# Access Compliance Report

### (Curb Ramps)

Intersection ID: 14482	Main Street: WALLACE_AV	Cross Street: WALLACE_GLEN_DR	Location: NE
ADA ID: 135BD6CD0CF1	Ramp Type: PerpDiag	Initial Pass/Fail: Fail	Overall Compliance: No
		Severity Score: 22.5

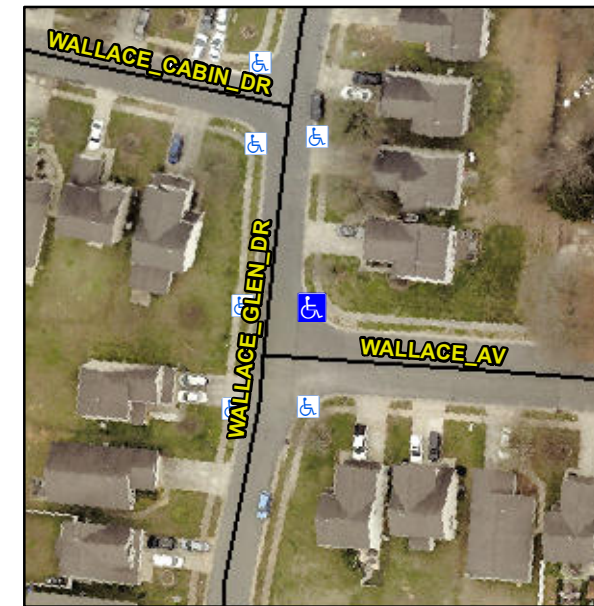
**R304.5.1, R304.2.2, R304.5.3**

Compliance	Description	Data	Compliance	Description	Data
N/A	Ramp Length (in)	49.5	No	Ramp Slope (%)	8.5
No	Ramp Width (in)	41.0	No	Ramp XSlope (%)	2.1
N/A	Flare Type LT	N/A	N/A	Flare Type RT	N/A
N/A	Flare Slope LT (%)	N/A	N/A	Flare Slope RT (%)	N/A
N/A	Flare Traversable LT?	N/A	N/A	Flare Traversable RT?	N/A
N/A	Landing Length (in)	N/A	N/A	DWS Provided?	N/A
N/A	Landing Width (in)	N/A	N/A	DWS Contrast?	N/A
N/A	Landing Slope (%)	N/A	N/A	DWS Length (in)	N/A
N/A	Landing X Slope (%)	N/A	N/A	DWS Full Width?	N/A
N/A	Landing Curb? (Y/N)	N/A	N/A	DWS Offset (in)	N/A
N/A	Shared Landing?	N/A			
N/A	Gutter Ponding?	N/A	N/A	Gutter Slope (%)	N/A
N/A	Gutter Lip Ht (in)	0.5	N/A	Gutter X Slope (%)	N/A
N/A	Painted X Walk1?	No	N/A	Painted X Walk2?	No
	X Walk 1 Direction	To W		X Walk 2 Direction	To S
N/A	X Walk 1 Width (in)	N/A	N/A	X Walk 2 Width (in)	N/A
	X Walk 1 Slope (%)	0.6		X Walk 2 Slope (%)	0.9
	X Walk 1 X Slope (%)	1.2		X Walk 2 X Slope (%)	0.3

**Remove & Replace Curb Ramp With Two New Directional Ramps or Equivalent.**
